CORIGENDUM – I

Ref: PUBLIC TENDER NOTICE N O:REQ/COMP/027/1011 DATED 27TH JULY 2010, on IIA website for Design, Supply, Installation, Testing and Commissioning of Computer/ Data Centre at IIA, Koramangala, as a turnkey project inclusive of relocation of computer equipments & accessories from existing computer rooms to the proposed datacenter at Ground floor. A concept drawing and specifications are in Annexure II.

CORRIGENDUM / ADDENDUM FOR THE PUBLISHED RFP OF DATACENTER

AUTOMATIC FLOOR PRESSURISING SYSTEMS (AFPS)

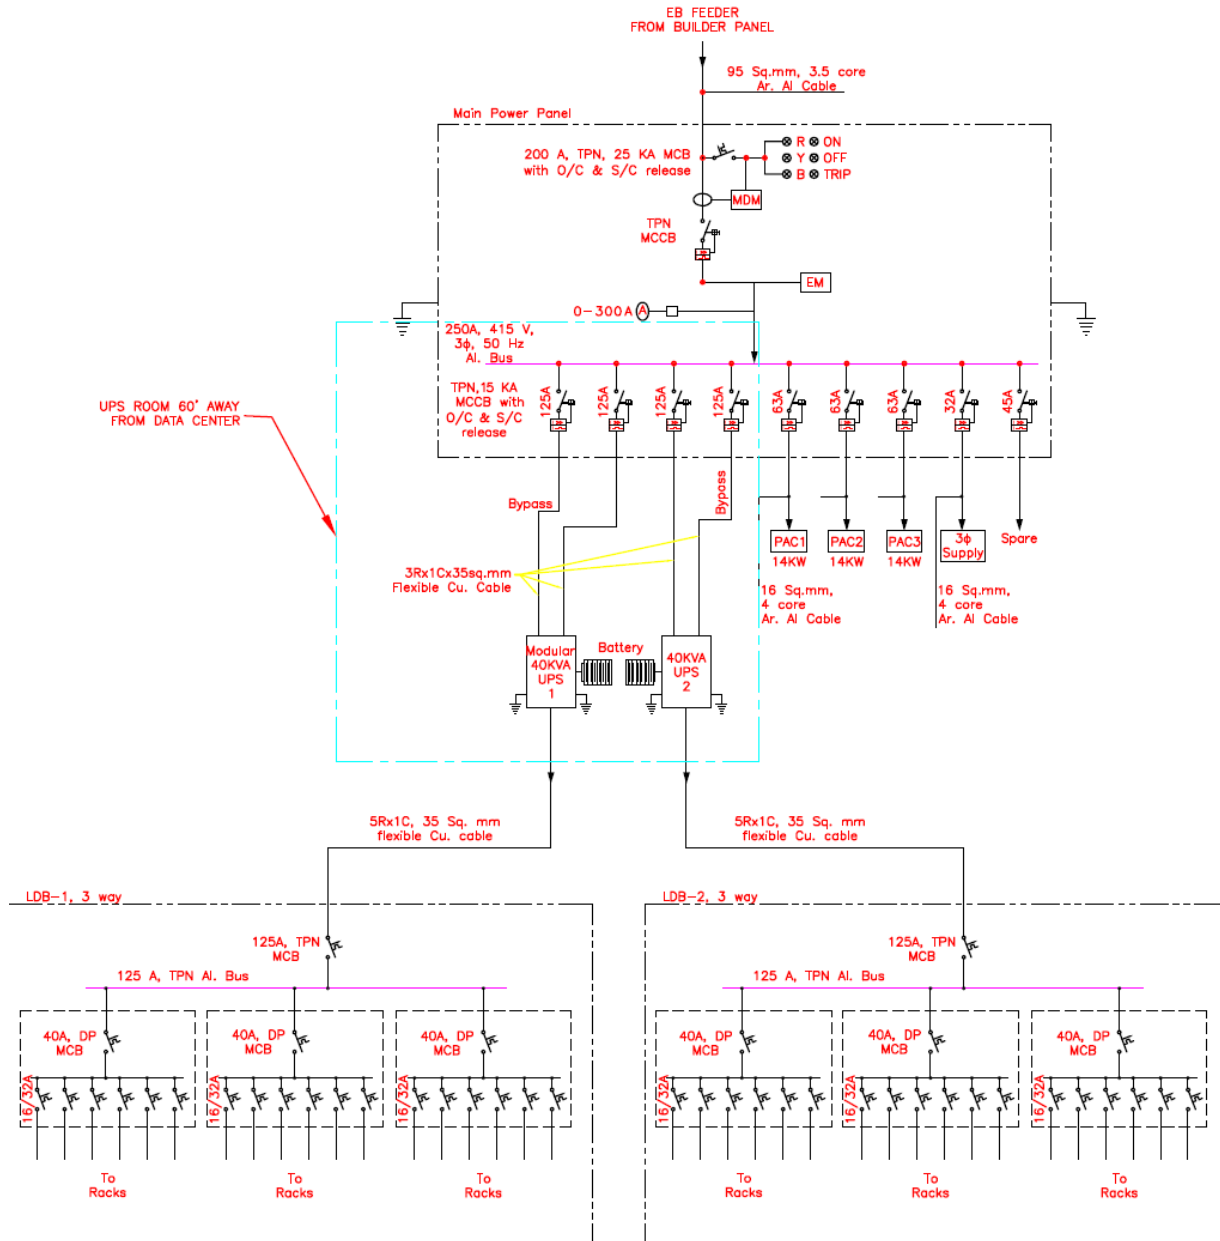
This system should sense the pressure below the Raised floor and it should give command to PAC units to regulate the flow of cold air inside the false floor.

Revised Electrical drawing

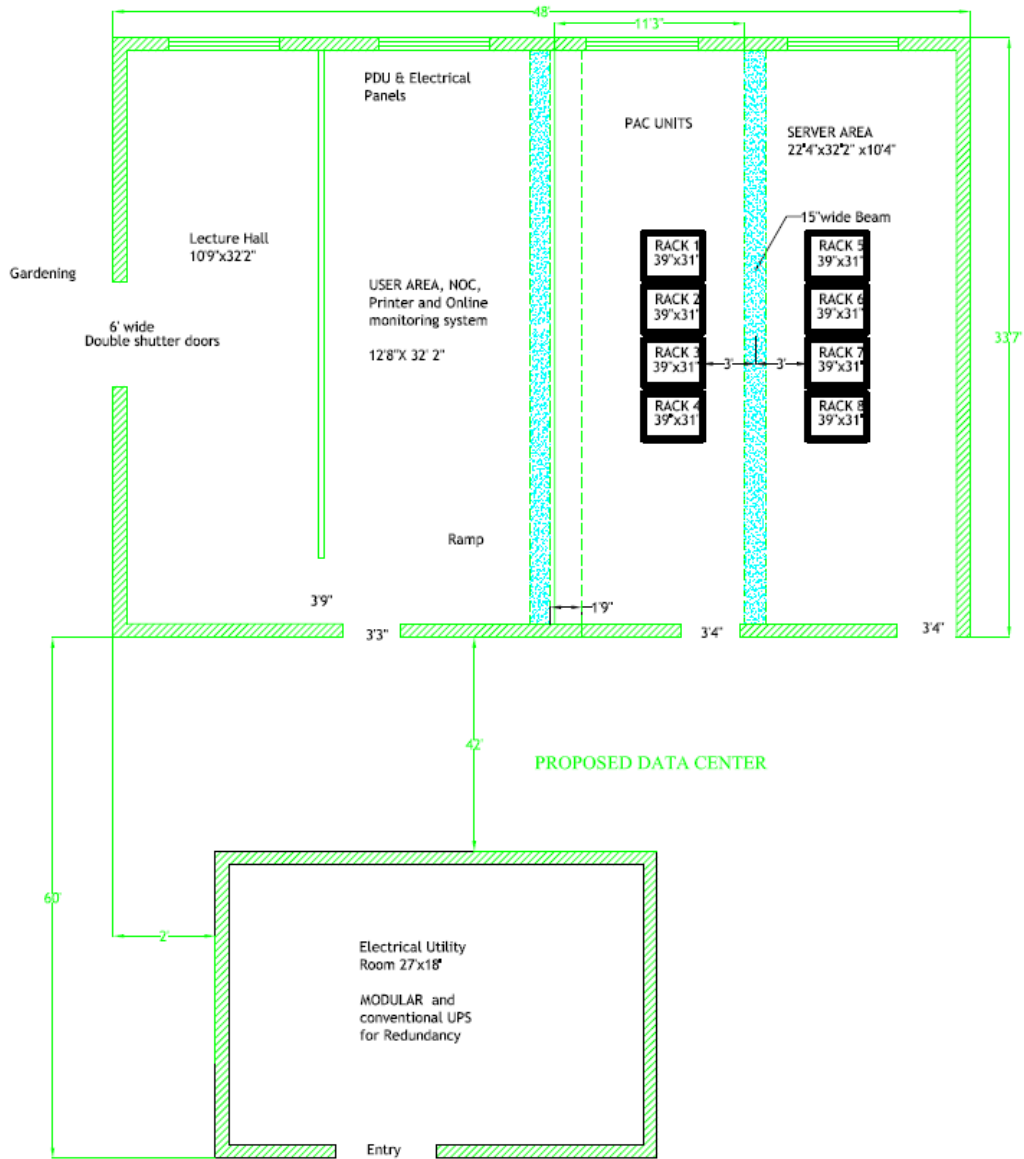
Page 33, Annexure –II, Electrical diagram provided in the RFP shows two input sources of Conventional UPS. The diagram has modified to accommodate one No of modular UPS with only one input and provision for the other input to connect conventional UPS as a redundancy. (Refer to the drawing in this document)
